**CASE NO. NEPR-MI-2019-0009**

**SUBJECT: Motion to Submit Final Technical Bulletin Regarding Smart Inverter Settings Sheets in Compliance with Resolution and Order of November 7, 2024, and Request for Agenda for Workshop Scheduled for November 21, 2024**

# SMART INVERTER SETTINGS SHEETS

November 15, 2024

Figure 2-2. Example Volt-Watt characteristics

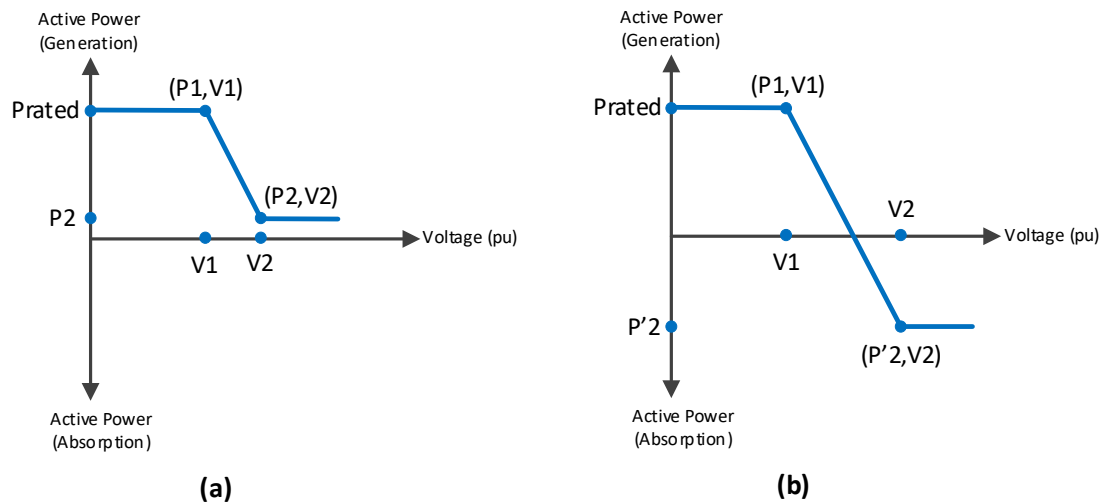
LUMA shall modify the Table 2-7 (Volt-Watt Settings) to reflect as "Activated" and shall modify the corresponding footnote (3) to read as follows:

(3) Will remain Deactivated for at least 6 months. Not earlier than June 30, 2025, the Energy Bureau will consider approving, through Resolution, the activation of this function after considering: (i) recommendations from LUMA and Working Group regarding system performance, (ii) implementation of adequate reporting and tracking requirements for customer curtailment, and (iii) LUMA has developed an effective plan to manage distribution voltage, that

Table 2-7- Volt-Watt Settings – <sup>(3)</sup>ACTIVATED

<sup>(3)</sup> Will remain Deactivated for at least 6 months. Not earlier than June 30, 2025, the Energy Bureau will consider approving, through Resolution, the activation of this function after considering: (i) recommendations from LUMA and Working Group regarding system performance, (ii) implementation of adequate reporting and tracking requirements for customer curtailment, and (iii) LUMA has developed an effective plan to manage distribution voltage, that relies on Volt-Watt functionality as a last resort mechanism to temporarily correct voltage issues.
